**Application for Minor Amendments
to the Building B5 Reserved Matters
Approval 2014/6968/P**

King's Cross Central General Partner Ltd

September 2015

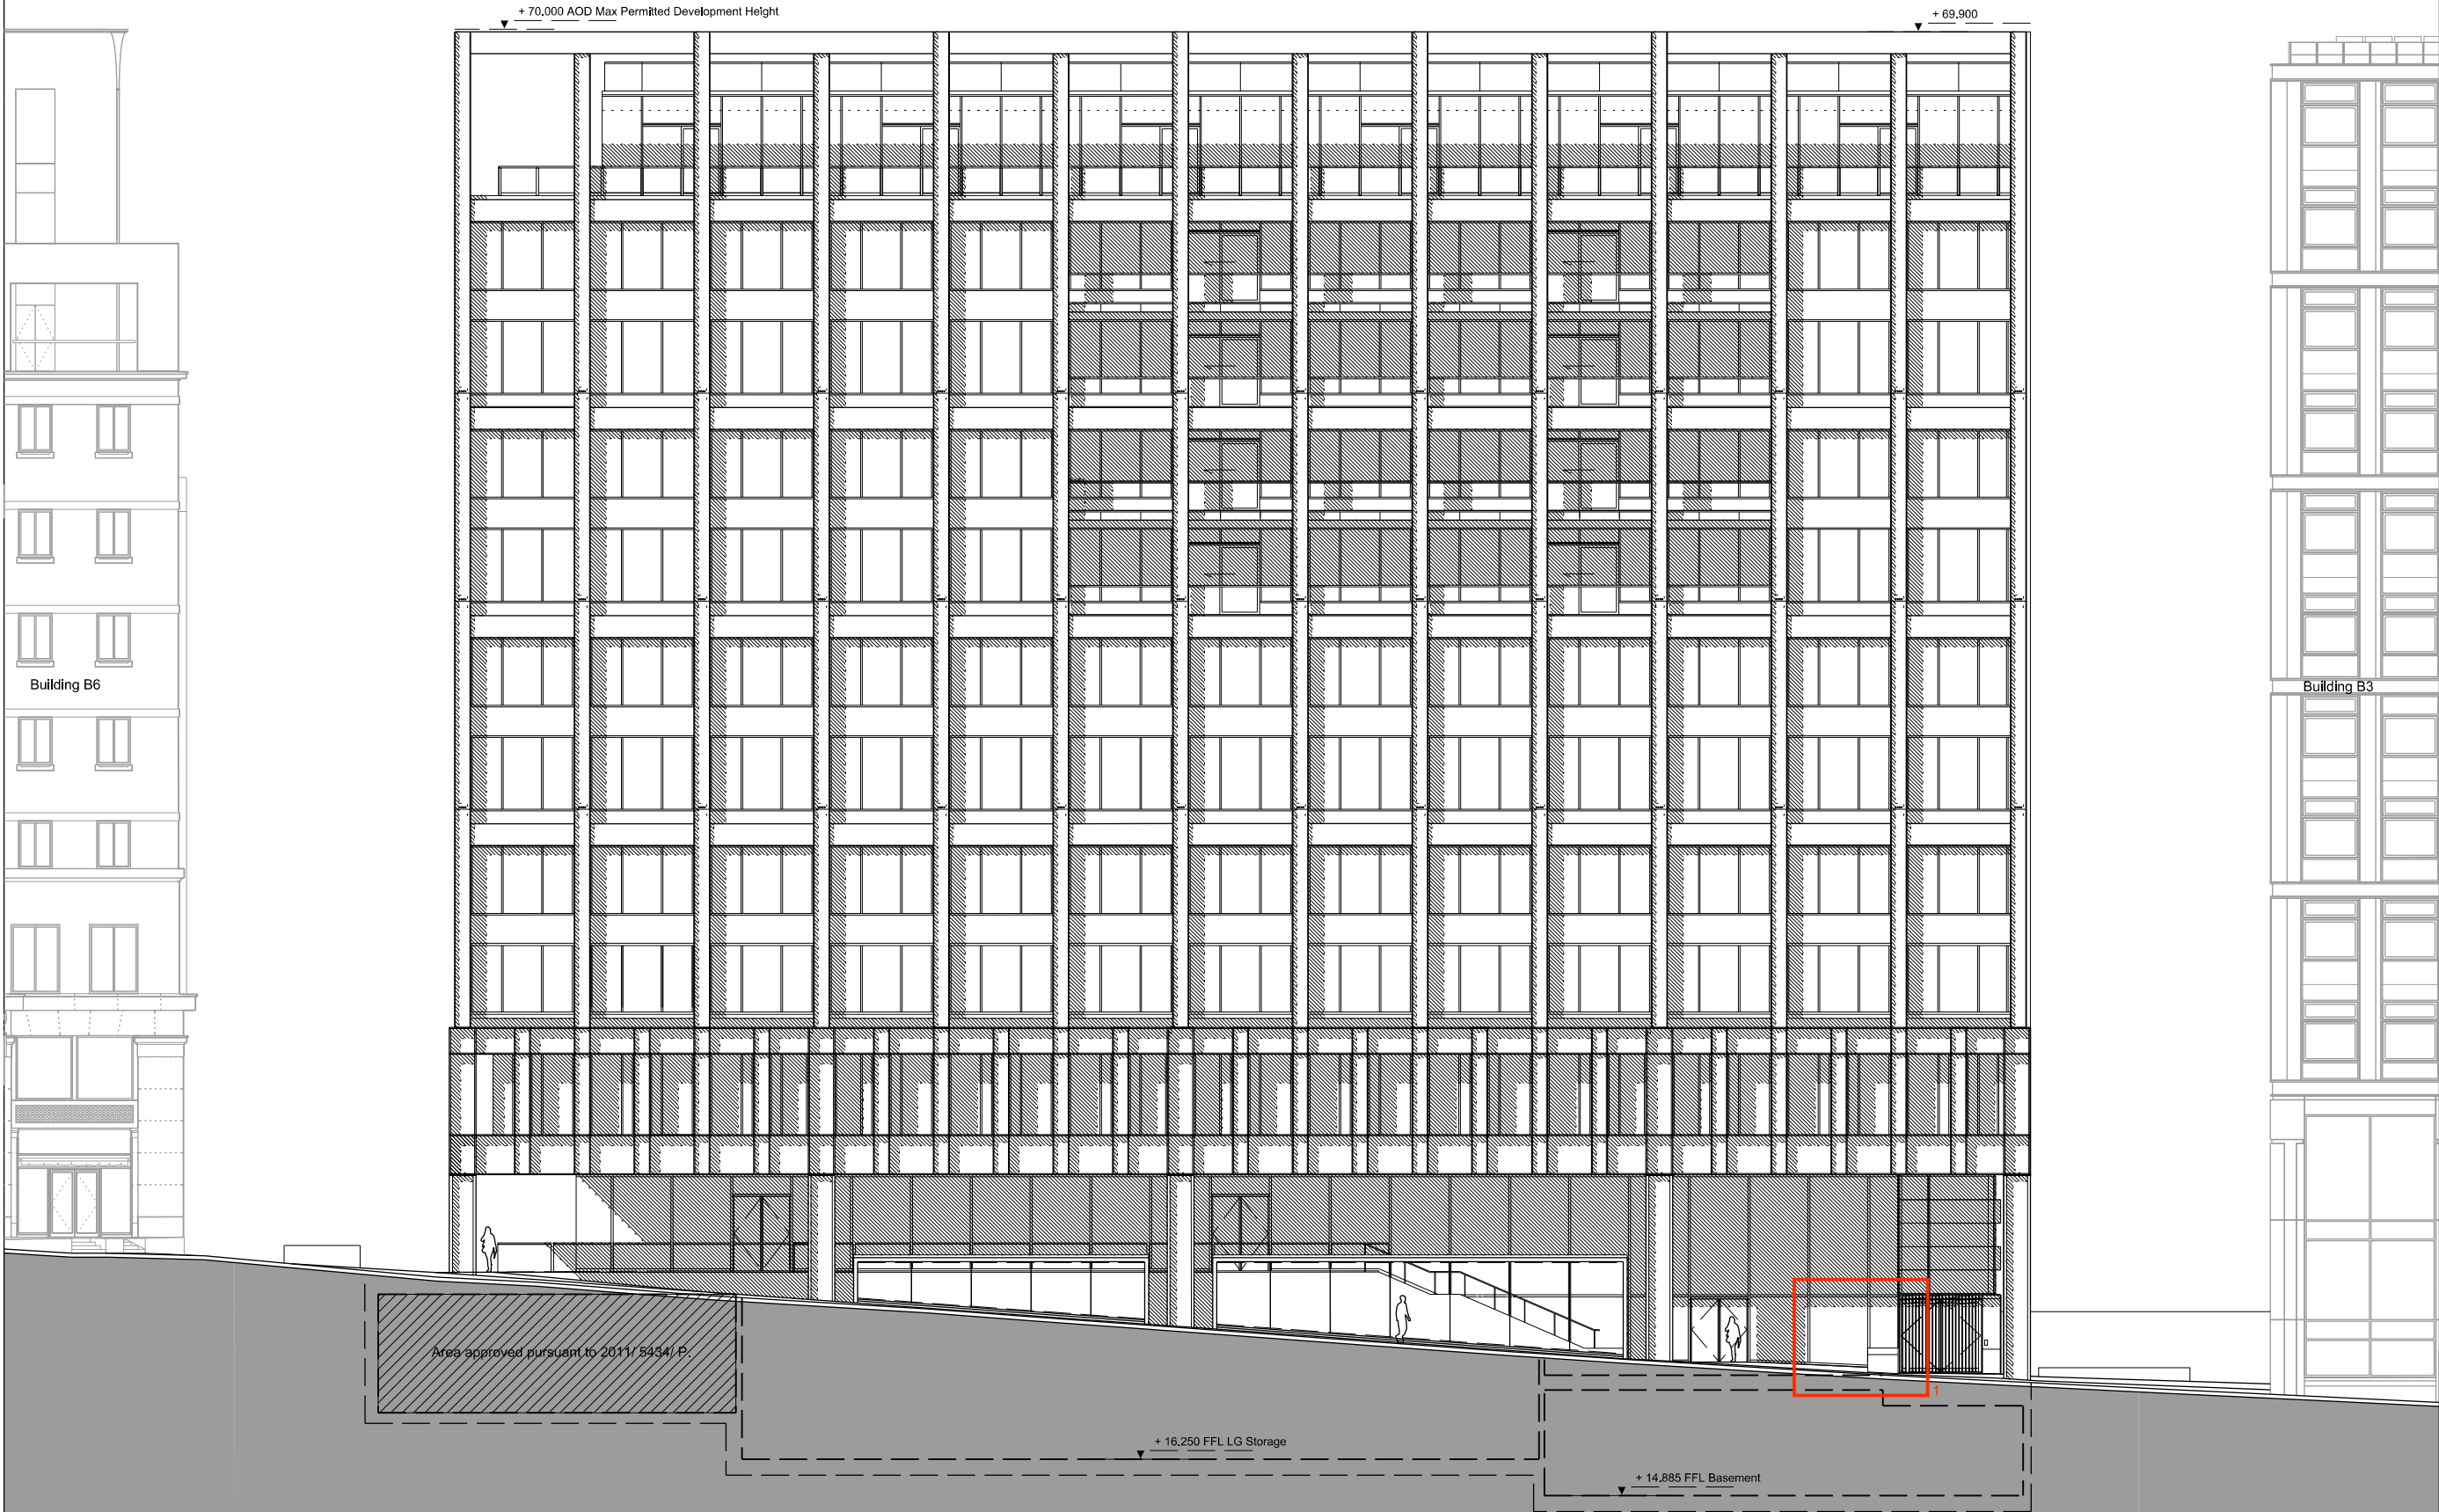
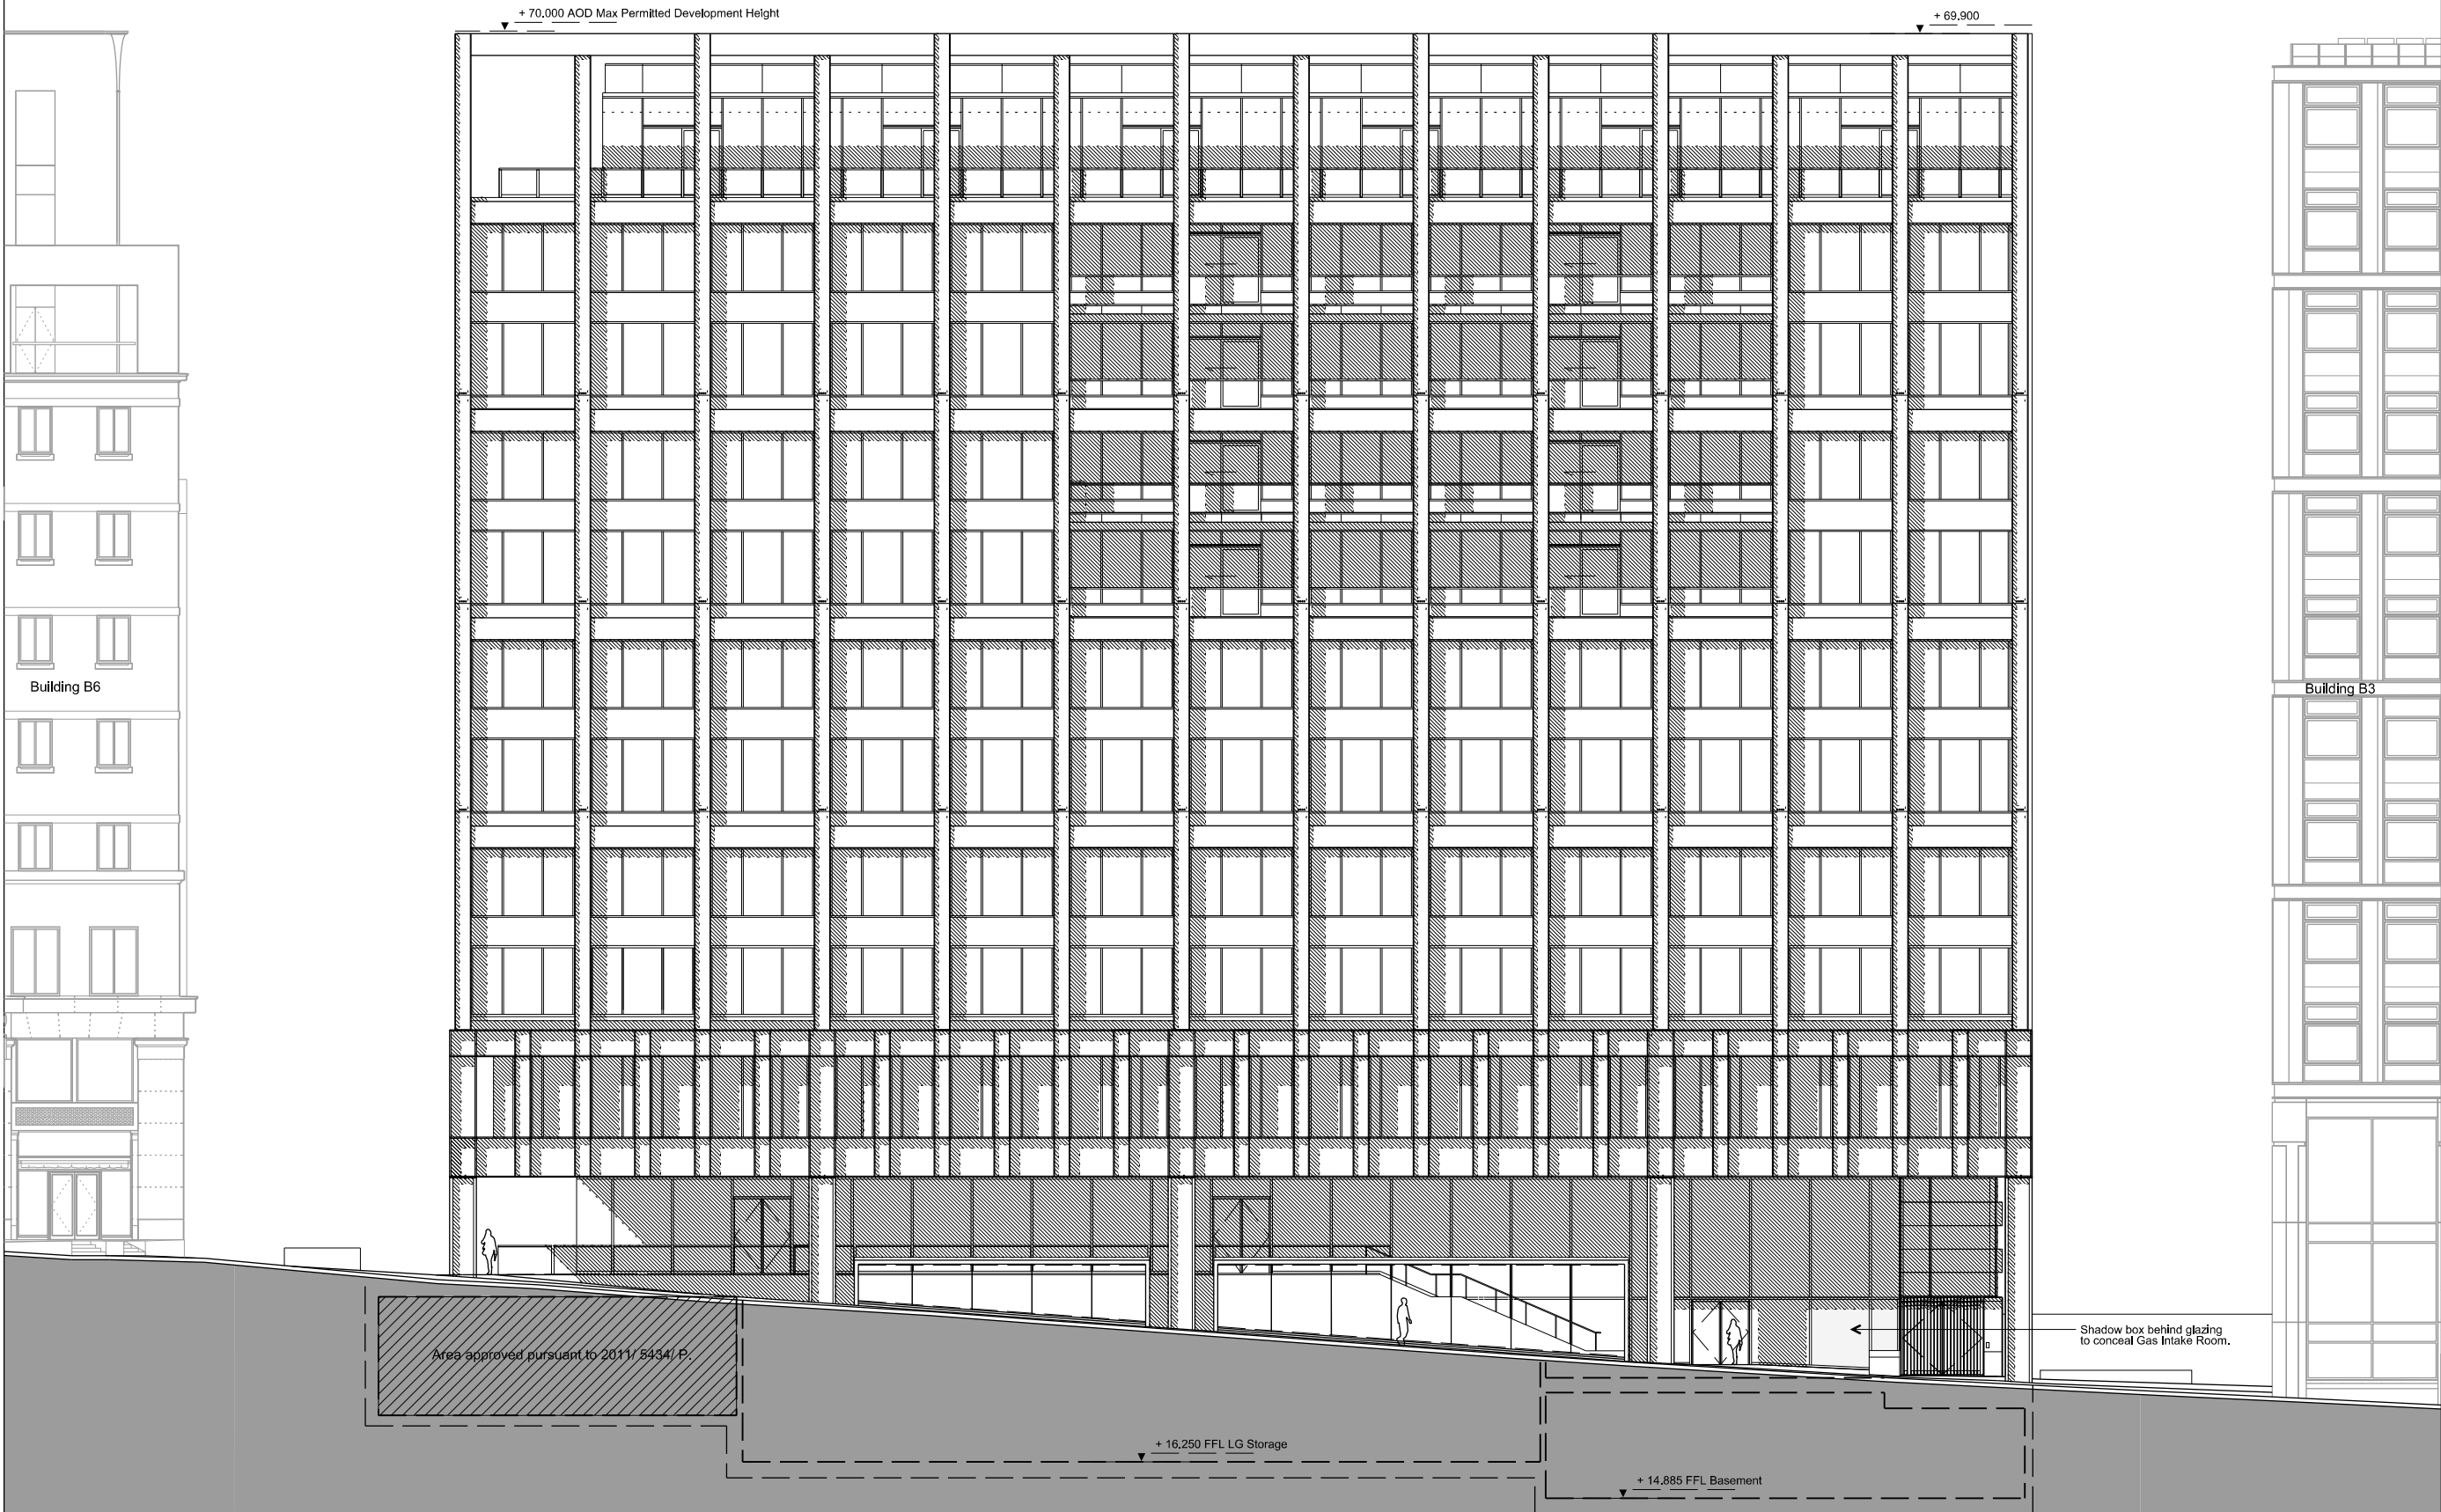
5. First floor plant rooms removed to release office floorspace; plant louvres replaced with glazing.

1. Removal of plant louvres shown incorrectly on the approved East and West Elevations.

drawing title Proposed GA West Elevation	scale 1 : 250 @ A3
drawing no EPA KXC 05 203	revision P0

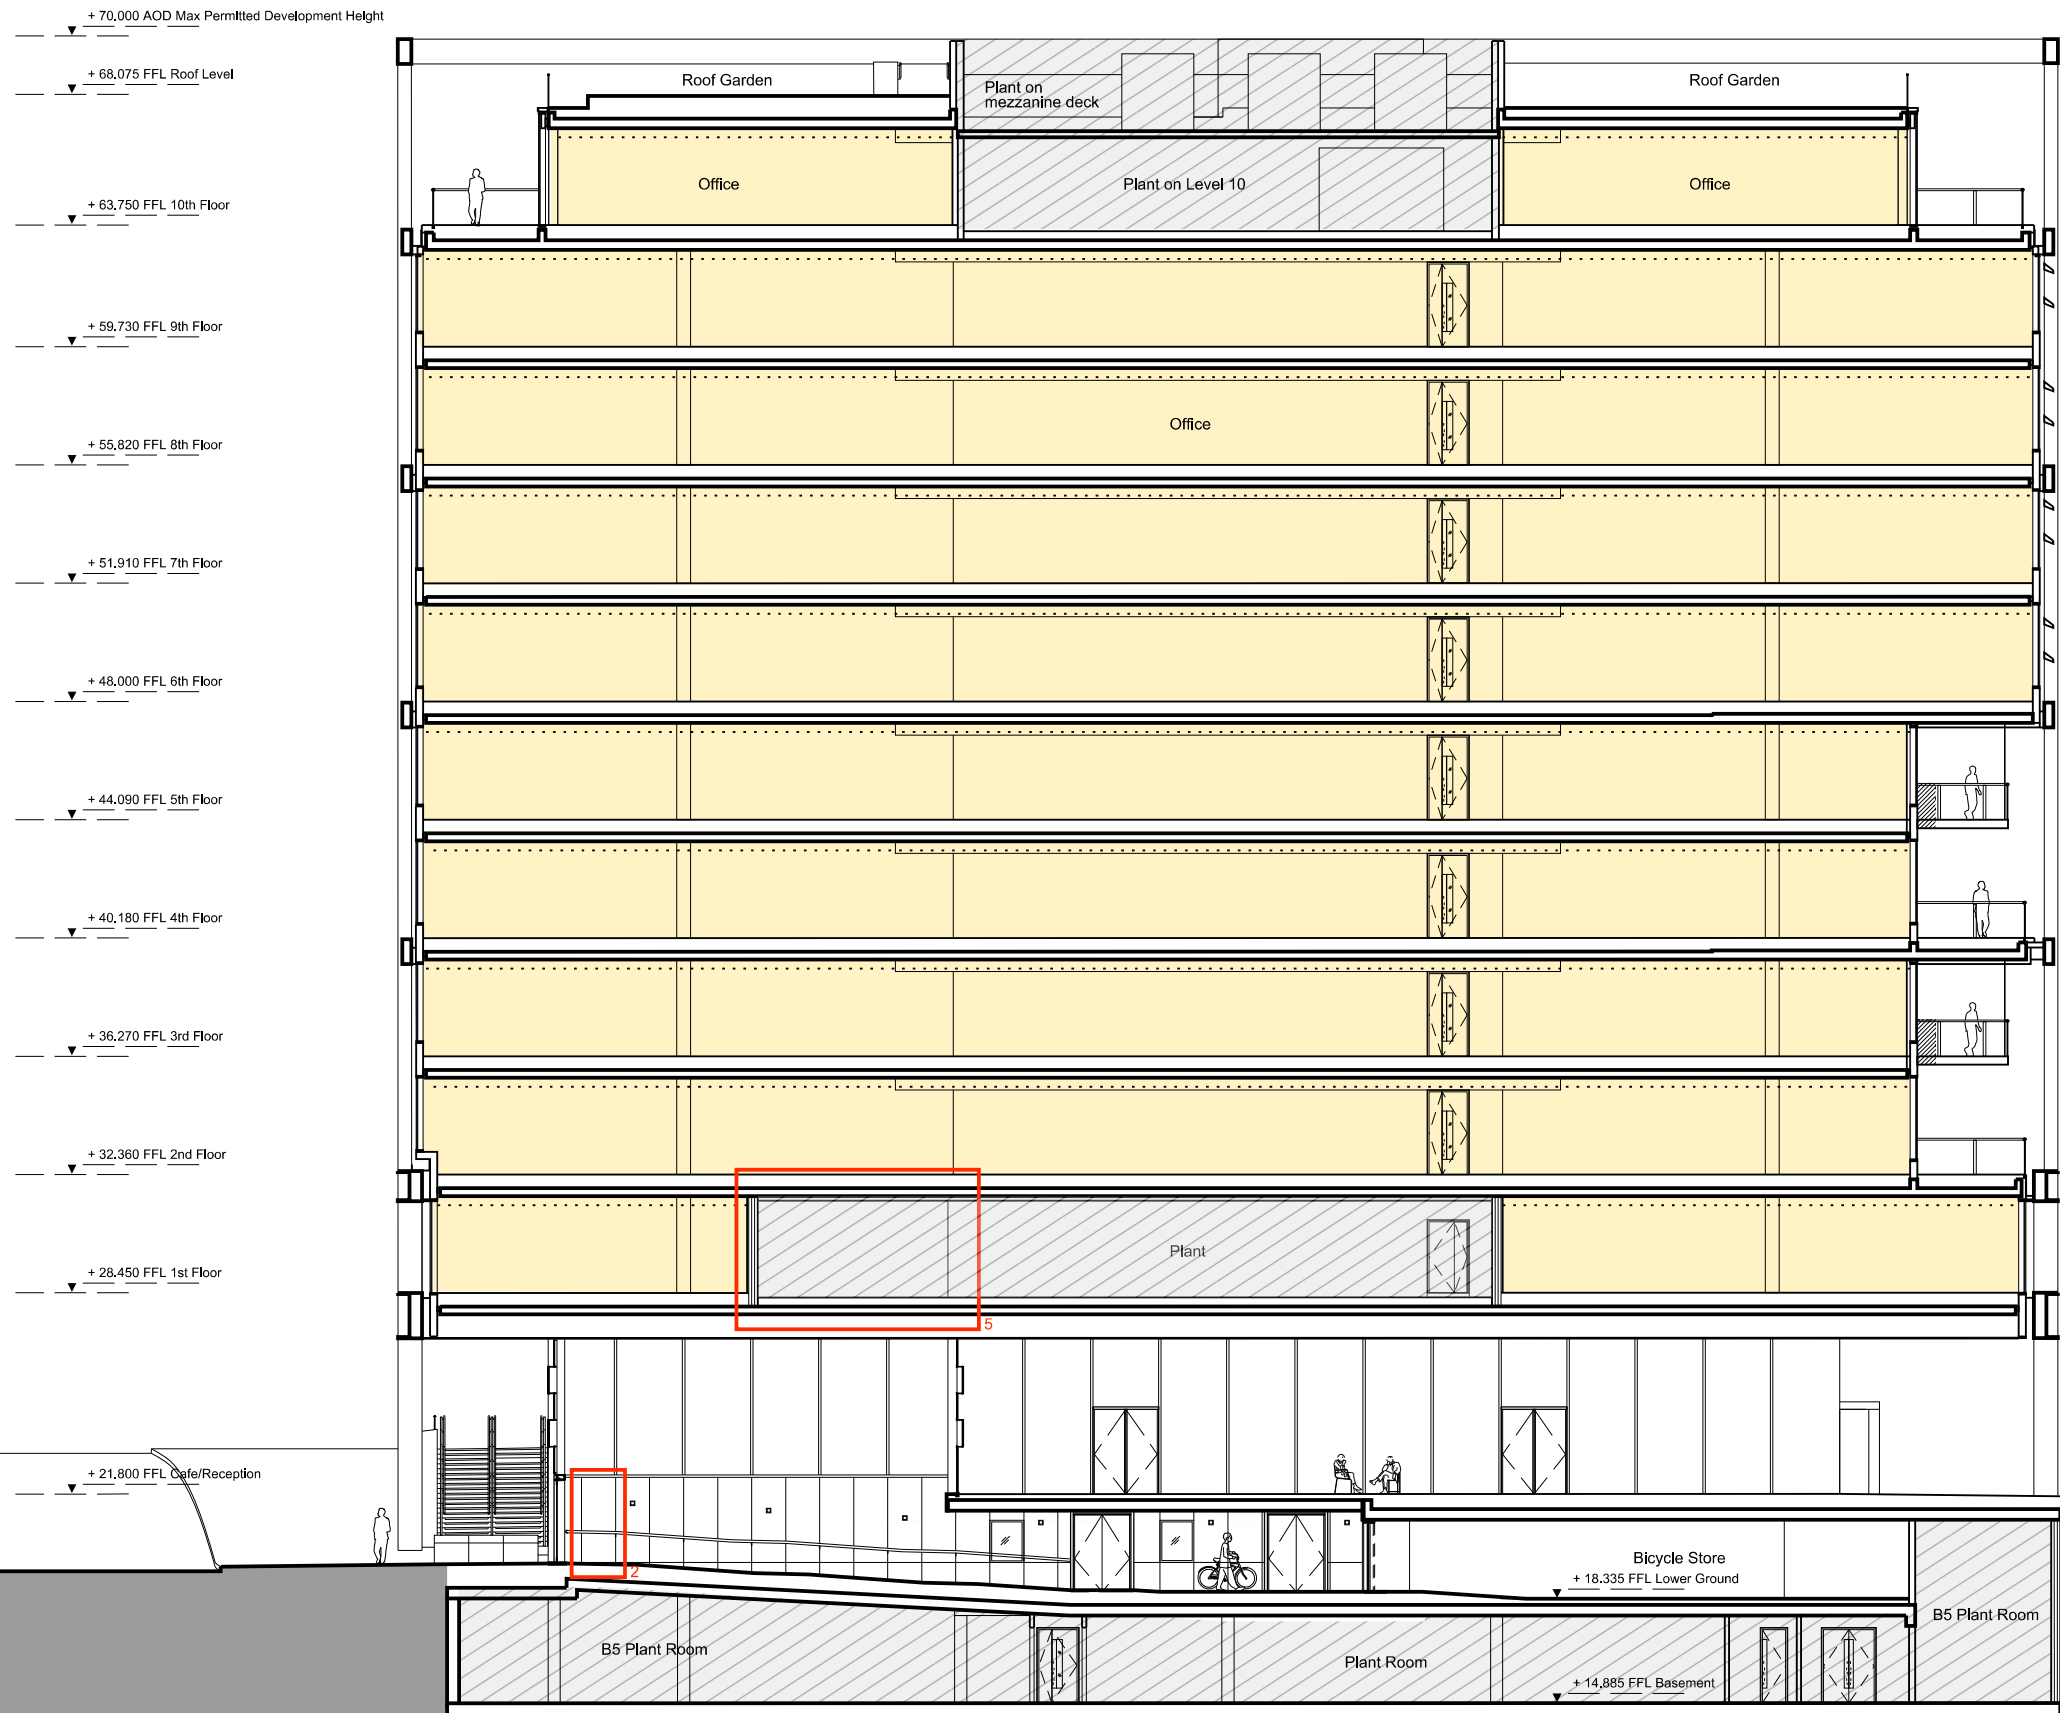
- THIS DRAWING IS COPYRIGHT.
No drawing shall be reproduced in any form without prior written permission of Eric Parry Architects.
- 2. Fourth inlet cabinet added.
 - 5. First floor plant rooms removed to release office floorspace; plant louvres replaced with glazing.
 - 6. Tenth floor plant louvre doors replaced with fixed louvre panels.
 - 1. Removal of plant louvres shown incorrectly on the approved East and West elevations.

P2	Planning Submission.	27/05/14	MM	MM
P1	Louvers removed at level 1 & louvre doors removed at level 10. Foam inlet added.	16/02/15	MM	RD
P0	Planning Submission.	29/09/14	JT	MM
Rev	Description	Date	By	Chk
